Alabama Port Authority

Addendum to R&P or Specification Booklet

Project Name McDuffie New East Electrical Building

Project No. 11734 **Task No.** 02 **Addendum No.** 3

DRAWING NUMBER 4643E-S1

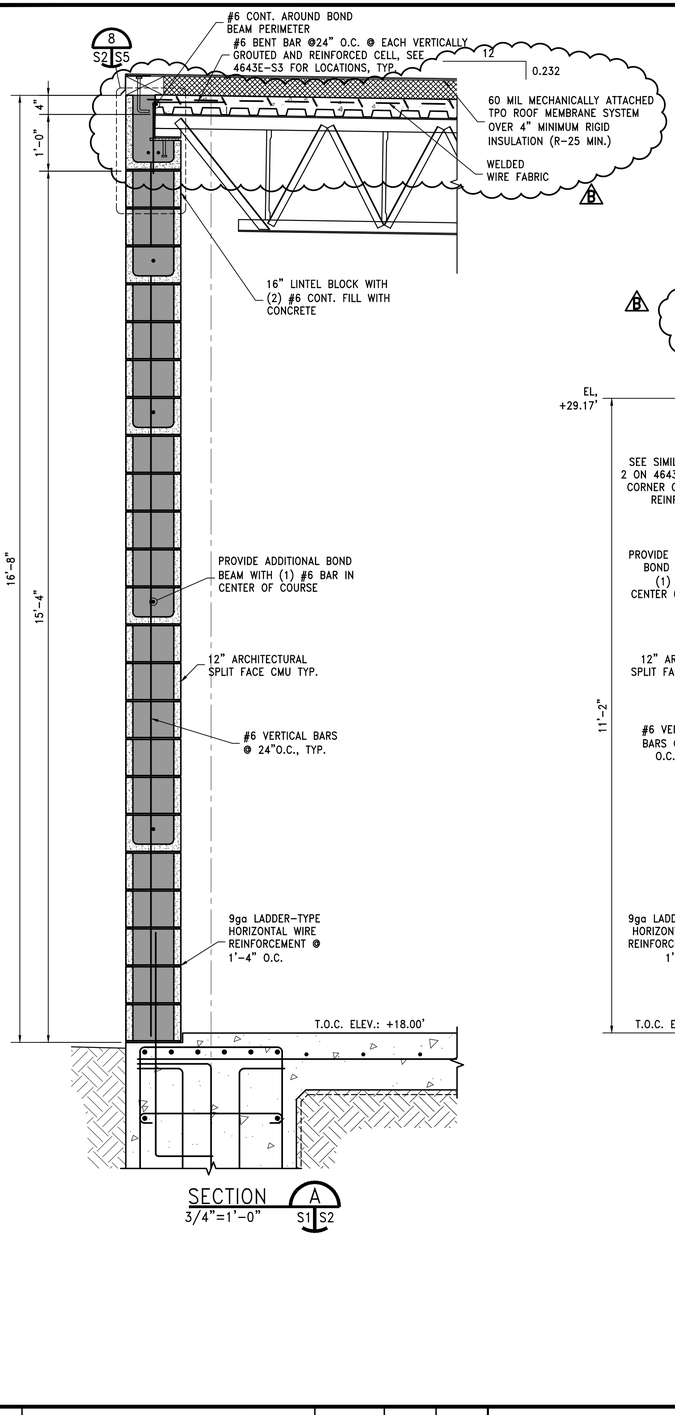
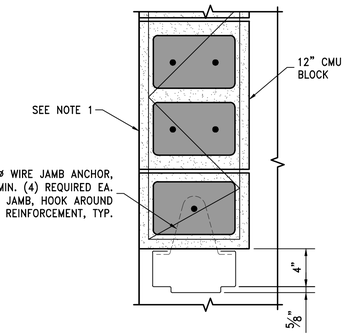
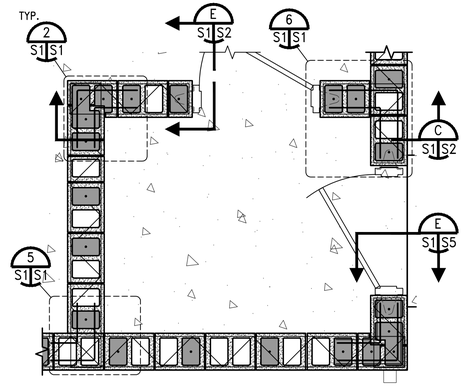
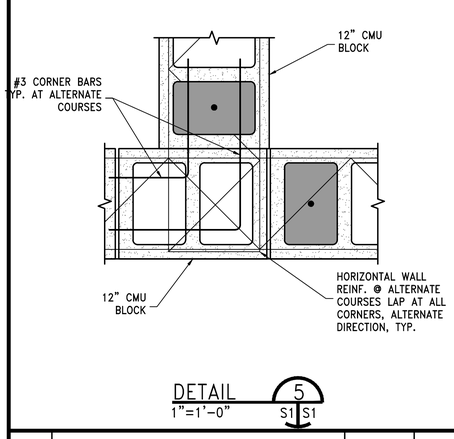
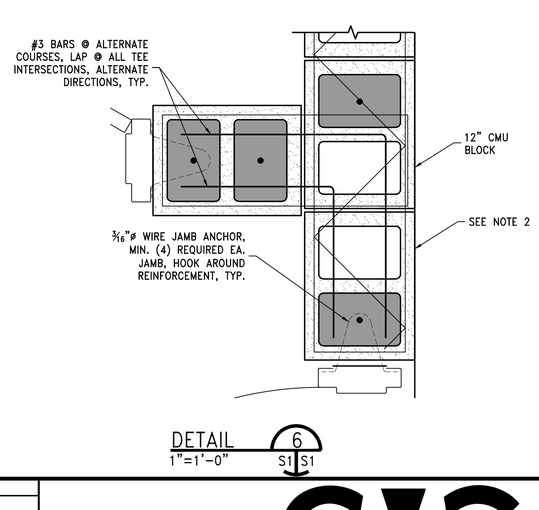
Item	Description
1.	See revised drawings 4643E-S1, S2, S3, S4 and S5 for roof deck, slab, insulation and 60 mil TPO membrane system clarifications and details. The roof deck will be comprised of a 4" (2.5" topper) slab on a Vulcraft 1.5 VL 20 metal deck. A minimum of 4" (R-25) of insulation shall be attached to the slab in accordance with the manufacturer's recommendations for a 159-mph wind. The roof membrane shall be a 60 mil TPO system, furnished and installed in accordance with the manufacturer's recommendations for a 20 year warranty. See attached Drawings E8 and E10 for electrical clarifications. See attached Pipe and Tube Railings (Handrails) and Chain Link Fences and Gates Specifications.

DRAWING NUMBER 4643E-S3

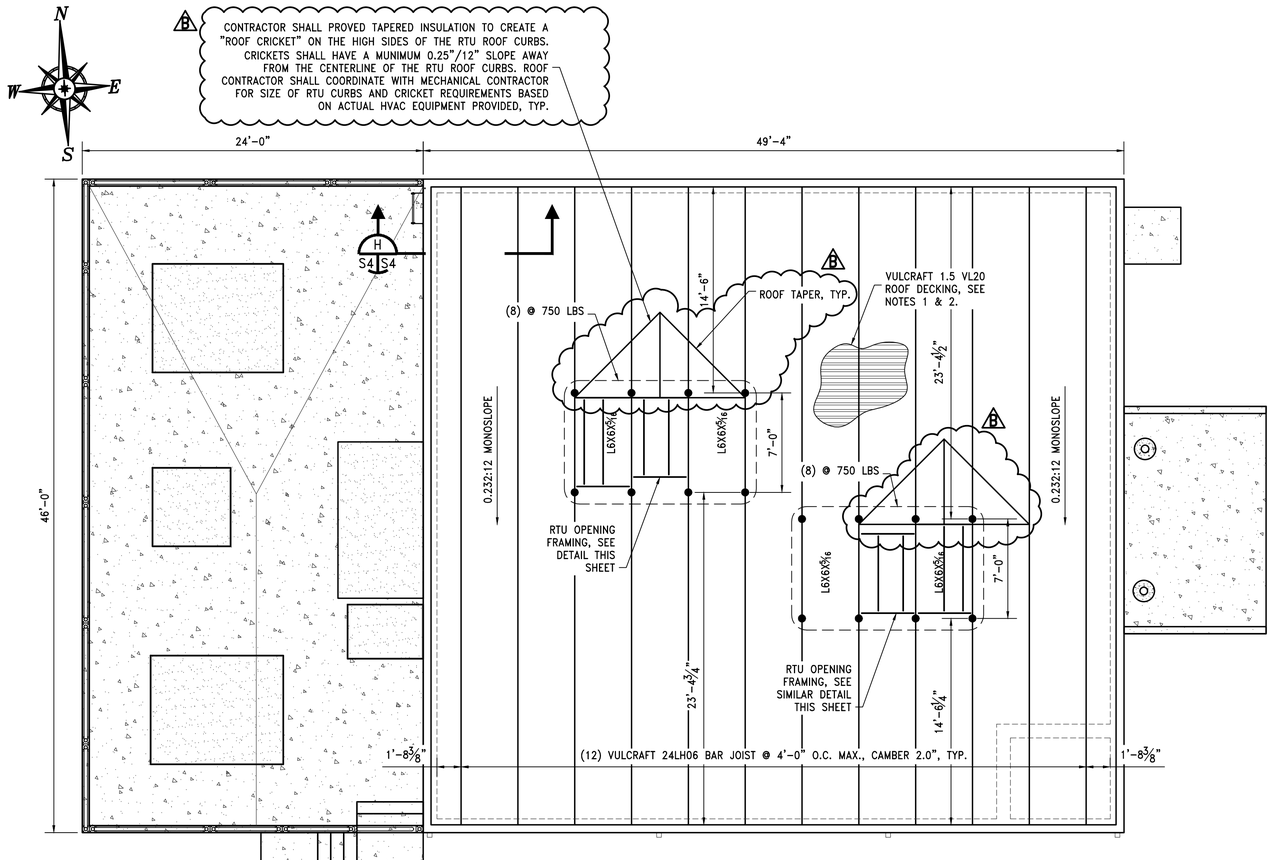
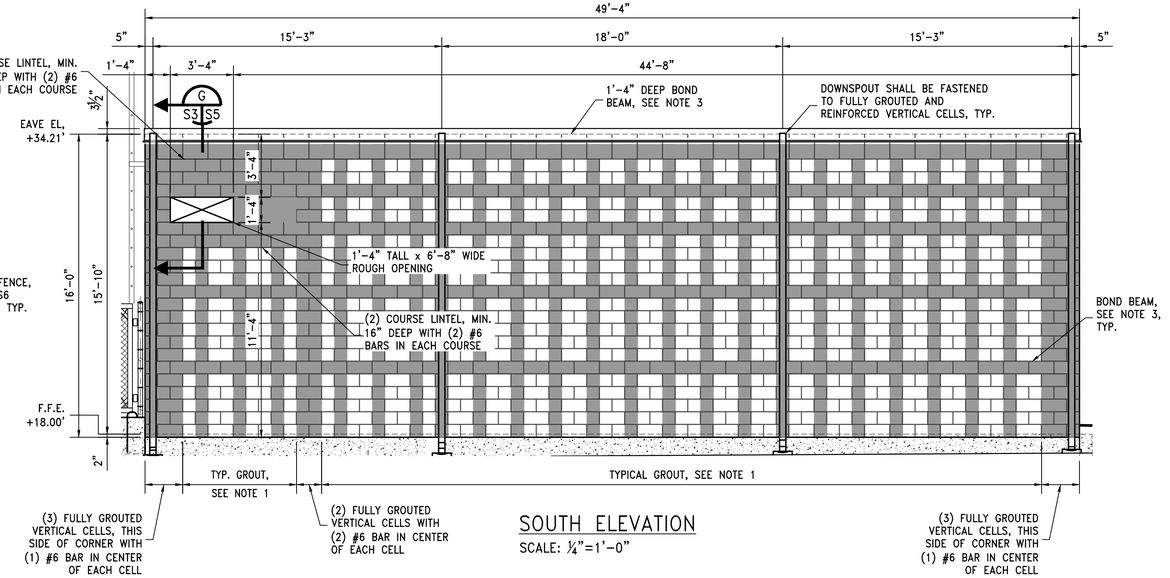
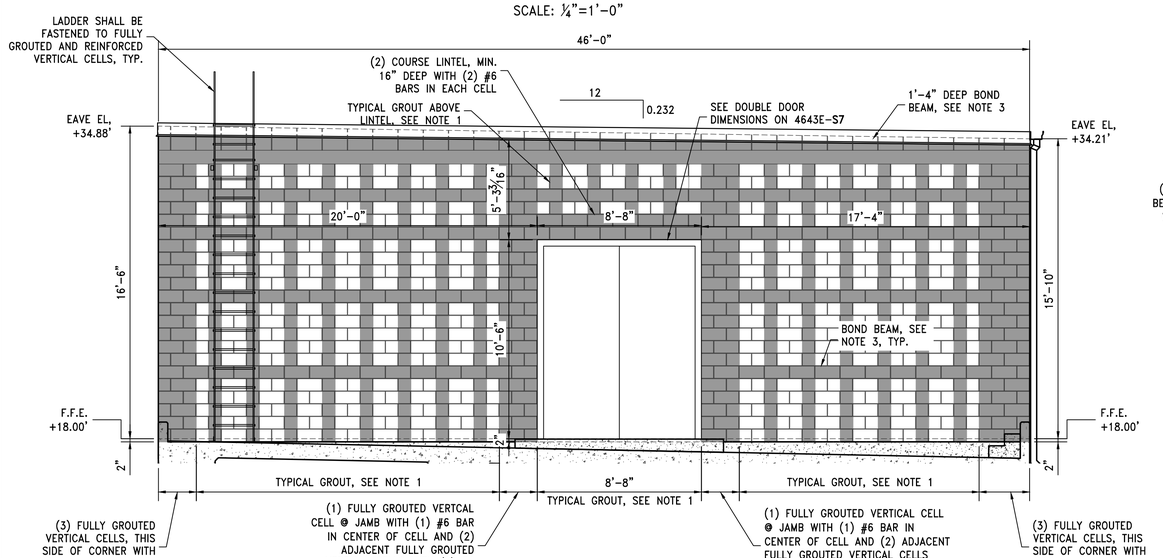
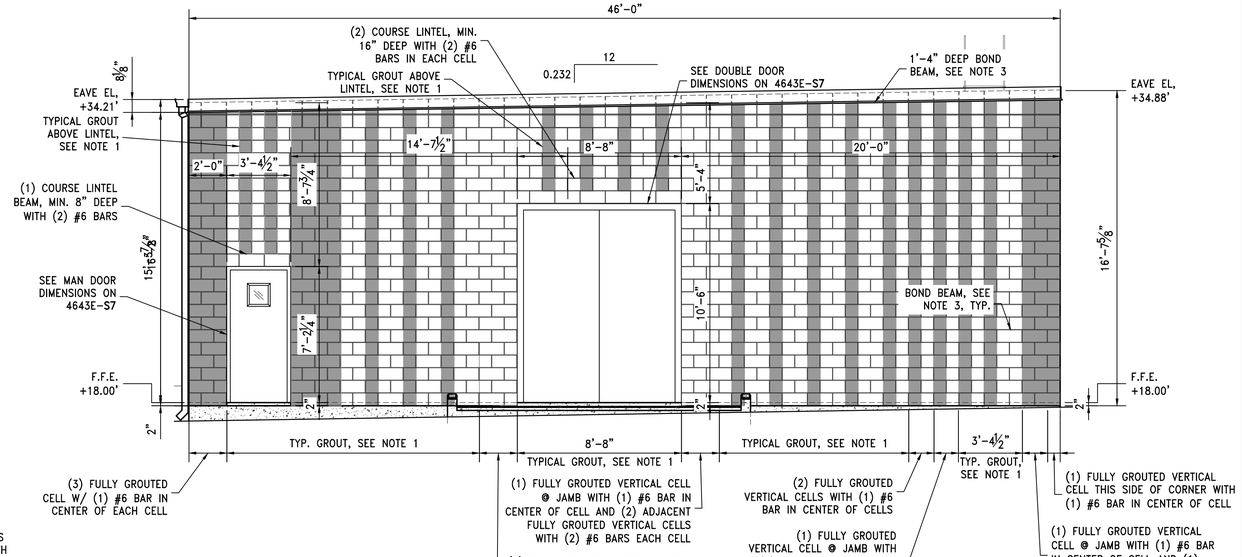
7.	Cricket locations, dimensions and slopes, including taper around both RTUs, with roof high/low points and flow directions. Gutter size, material, slope and outlets; all four downspout sizes, locations and discharge routes; and splash block dimensions. Confirmation of the primary and secondary/overflow drainage arrangement, including whether roof drains or overflow scuppers are required. If required, please provide locations, sizes, elevations and details. See drawing S1 for cricket location, dimensions, etc. Gutter size 5" wide x 6" deep minimum, provide calculation with shop drawing submittals to confirm capacity. Minimum 4" x 6" downspout, provide calculation with shop drawing submittals to confirm capacity. See drawing 4643E-S3 for downspout locations. Overflow scuppers NOT required.
